RE: Peer Review of Kariong Sand and Soil Supplies Air Quality Impact Assessment Response to Submissions

Todoroski Air Sciences (TAS) has reviewed the *Kariong Sand and Soil Supplies Air Quality Assessment – RTS* prepared by Northstar Air Quality (dated 10 December 2020) on behalf of five nearby landowners of Acacia Road and Debenham Road, Somersby (Lot 3 239 Debenham Rd East, Somersby, 252 Debenham Rd East, Somersby, 242 Debenham Rd East, Somersby, 10 Acacia Rd, Somersby, 12 Acacia Rd, Somersby).

This review of the response to submissions (RTS) follows the peer review undertaken by TAS (dated 22 September 2020) of the *Kariong Sand and Soil Supplies – Proposed Development Air Quality Impact Assessment (Northstar Air Quality, 2020a)*.

Figure 1: AERMET generated windrose

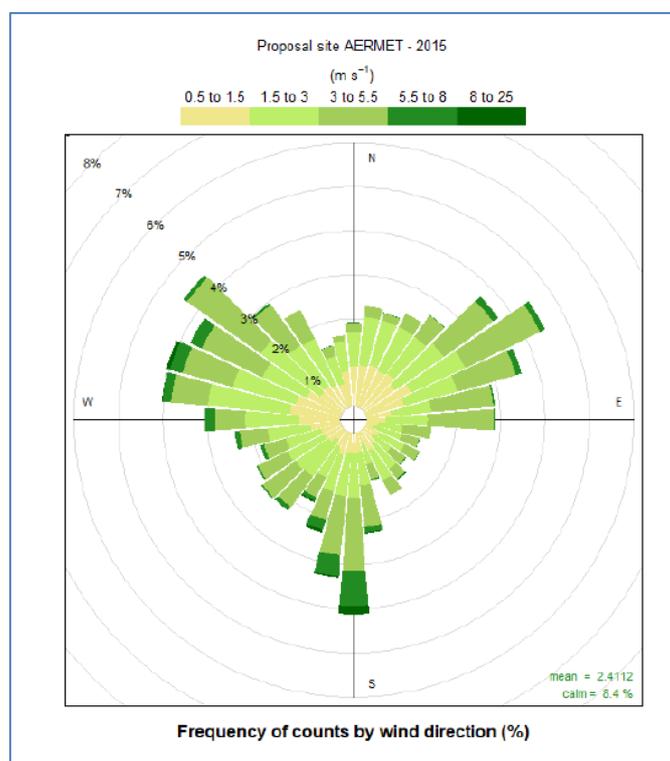
The AERMET generated windrose is presented in **Figure 2** and for comparison, **Figure 3** presents the Gosford AWS windroses. The AERMET windrose shows similar wind patterns to the Gosford data.

The features in the observed Gosford AWS windrose can be directly related to the geographical features near the weather station; the large flat body of water to the south means that strong southerly winds are more likely (as we see in the windrose), the steep wooded ridge to the north will block northerly winds, and enhance NW and NE winds (as is the case) (see **Figure 4**). It is important to note that there are no such features at the project site (see **Figure 4**), hence there will be different wind conditions, and there is no reason to expect similar wind conditions at the project site to those at Gosford AWS. However, the AERMET modelling shows no significant differences between the site windrose and the Gosford AWS windrose.

This means the AERMET data used in the air dispersion modelling is not representative of the project location. This is acknowledged in the AQIA which says *“Although the data do not represent site specific conditions (i.e. at the project site), no data is available to allow an assessment of that meteorological environment”*. It is important to note that unrepresentative meteorological data may cause invalid or incorrect dust modelling results.

Figure 3: Geographical features of the area, location of Gosford AWS, Project site and “CALMET Extract”

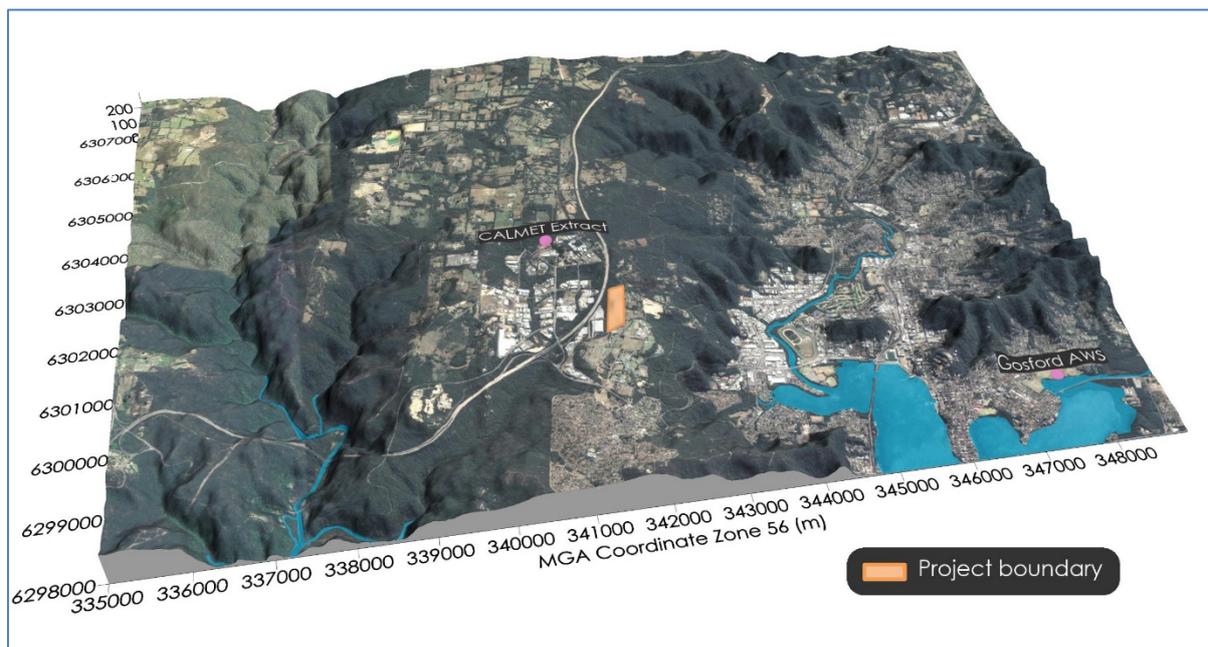
It is to be noted that the Gosford AWS station is located in flat terrain near sports fields, north of a large body of water, and south of a steep wooded ridge which runs approximately east-west. On the other hand, the project site is positioned on the western ridgeline or plateau at a significantly greater elevation to the Gosford meteorological station, and does not have elevated terrain to the north, or flat level terrain nearby or to the south.

Due to these significantly different geographical features, the winds at the project site will be significantly different to those as Gosford AWS. These different features will necessarily cause the project site and monitoring station to experience significant meteorological conditions, that is, wind speed and wind direction will be affected by different anabatic and katabatic processes, differing nearby land surfaces and will be subject to different southerly and northerly flow and wind speeds.

Meteorological modelling by the reviewer has been made for a location near to the project site, shown as “CALMET Extract” in **Figure 4**. These data can be used for a relative comparative assessment of the meteorological environment near the project site. A windrose showing the reviewer’s results is presented in **Figure 5**, and is provided to indicate the weather conditions which are more likely to be experienced near the project site as may be expected due to the geographical features near the project site. It is also noted that due to differing geographical features in the area, there will also be some difference between different locations along the plateau or ridgeline also, however these local geographical differences would be smaller than those between the project site and the location of the Gosford AWS.

Figure 4: Indicative windrose at “CALMET Extract” location, likely more representative of the project site.

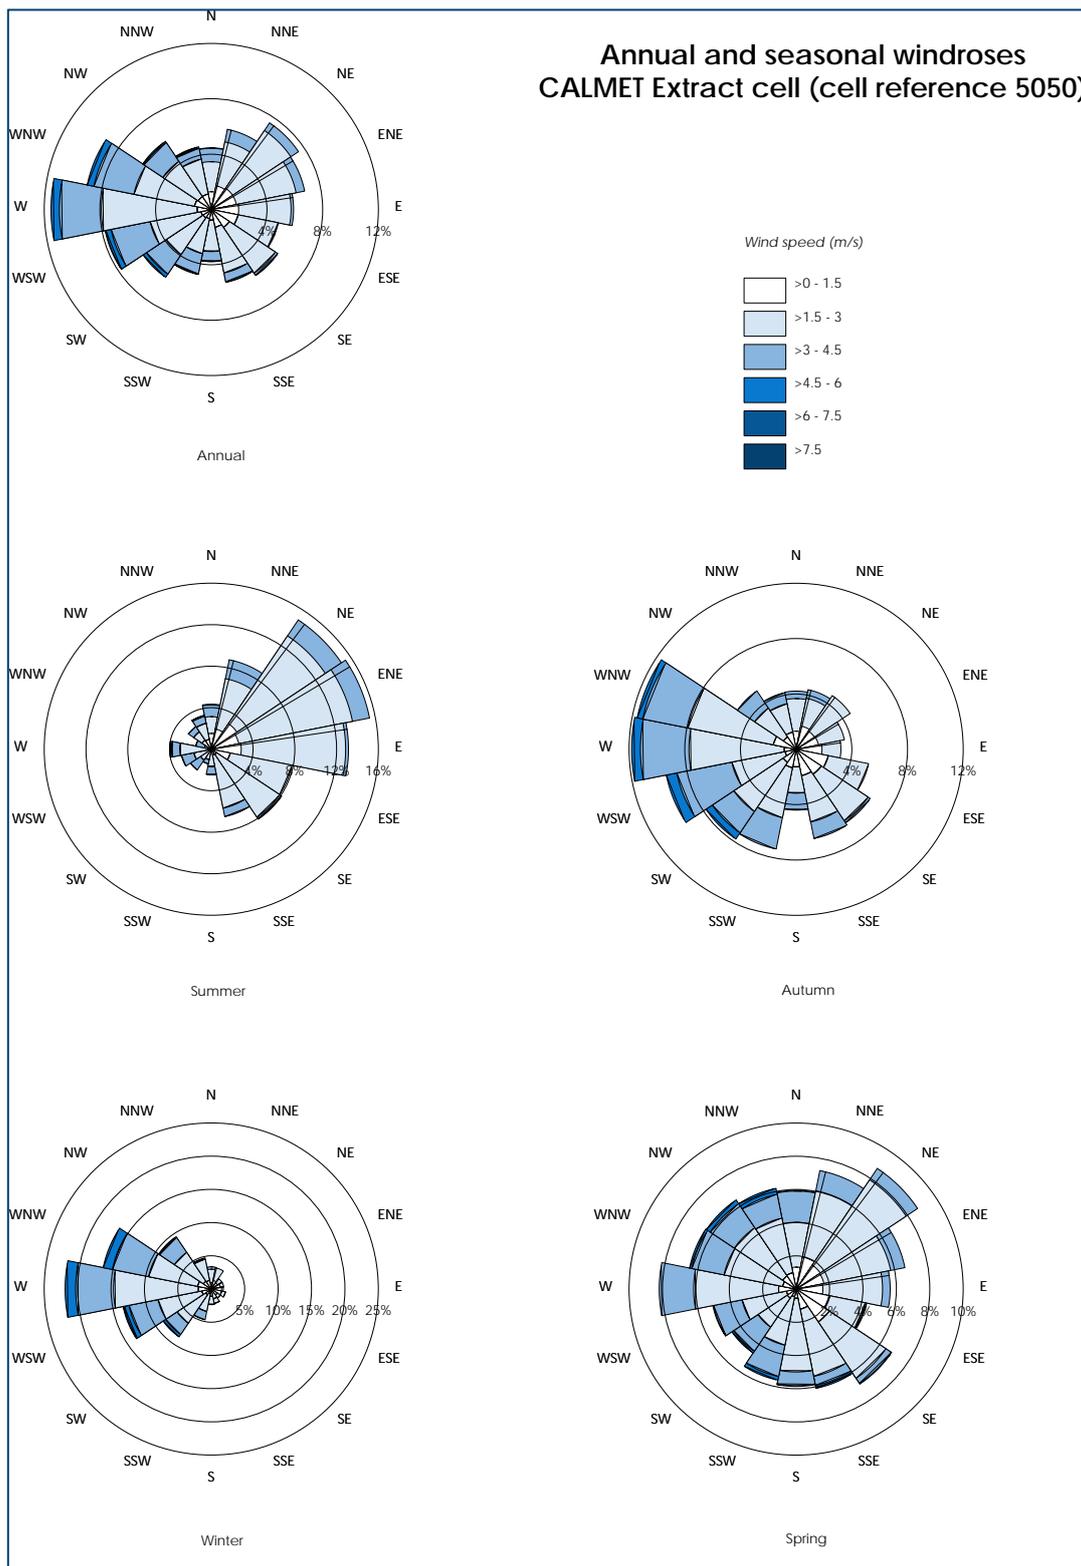
The indication from the above is that relative to the modelled winds, there are likely to be less southerly winds and more westerly winds present near the project site, i.e. more winds towards the nearest receptors. This is especially the case in the winter time, which generally tends to coincide with the poorest air dispersion.

Thus, the weather inputs and model used have potential to lead to invalid or incorrect results.

As discussed in detail in the AQIA, the meteorological data adopted in the performance of the assessment were a result of numerous meteorological modelling sensitivity exercises, where model outputs could not be adequately validated against the limited observations in the area (i.e. Gosford AWS). It is acknowledged that these data are not representative of the site, and they are not presented as such in the AQIA.

It is noted that the reviewer has provided a 'CALMET extract' of a meteorological model output for the project site and states that these would be 'likely more representative of the project site'. However, without adequate validation of those modelling results with observations, that statement cannot be supported to any degree and the data presented by the reviewer may be no more reflective of site conditions than that presented in the AQIA. Interestingly, the reviewer's presented annual wind rose for the project site compare well with that modelled in the original AQIA (2018) using no data assimilation and the TAPM model. However, that model did not validate well against observations at Gosford AWS which prompted NSW EPA to request an alternative meteorological modelling approach/method.

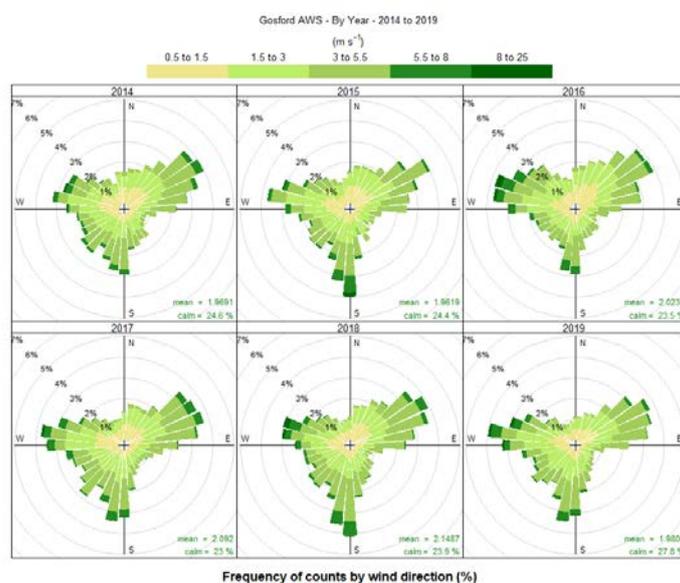
There are obvious, large, significantly different geographical features and influencing factors between the site and at the Gosford AWS, and these features will result in significant differences in the wind flows at the site relative to the Gosford AWS. Validating meteorological predictions at the Project with Gosford AWS, (i.e. with the aim of making them similar) is not logical or valid.

It is appreciated that the Reviewer's comments may be at odds with how the EPA request has been interpreted/ acted on by the consultant, and also that the comments broadly align with the consultants original meteorological modelling. However, any reliable meteorological data for this location will not show the biases that arise at the Gosford location, as outlined in the original comments, simply because the locality does not have the large influencing factors that are present at Gosford.

There is an onus on the consultant to use the most valid data, and to achieve this, they may need to modify how they have responded to the EPA advice. (i.e it is not clear that the EPA actually expects that the site data would be similar to that at Gosford).

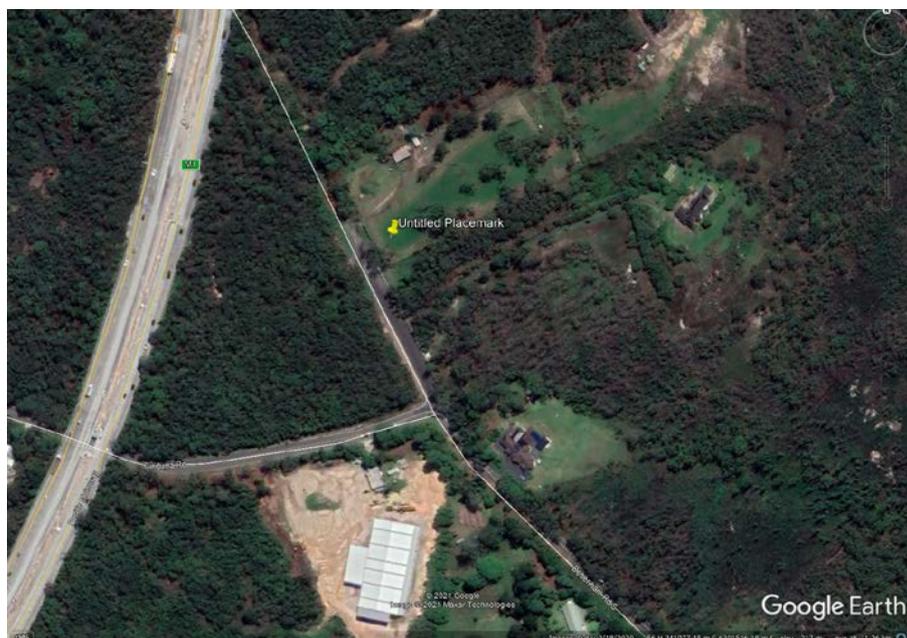
It is noted that not all of the existing and likely future receptors have been modelled. Notably, the proposed dwelling at Lot 3 239 Debenham Rd East, Somersby is not considered, nor is the juvenile corrections centre, where there may be many young persons present at any time. The corrections centre may warrant some additional consideration, given that inmates may be present for long periods and may be unable to leave for any respite.

Two receptors represent potential impacts at the correction centre (Receptor 16 and 19) as indicated in Table 6 of the AQIA. Debenham Road East could not be identified on any maps, and the reviewer was contacted to confirm the location referenced in the peer review, although no reply was received.

Impacts have been predicted at receptor R1 (242 Debenham Rd South) which is adjacent to (and closer to the project site than) 239 Debenham Road South and can be used as a reasonable proxy for those potential impacts.

Impacts have also been predicted at receptor I1 (244 Debenham Rd North) which is adjacent to 239 Debenham Rd North, and can be used as a reasonable proxy for those potential impacts given that it is located nearby.
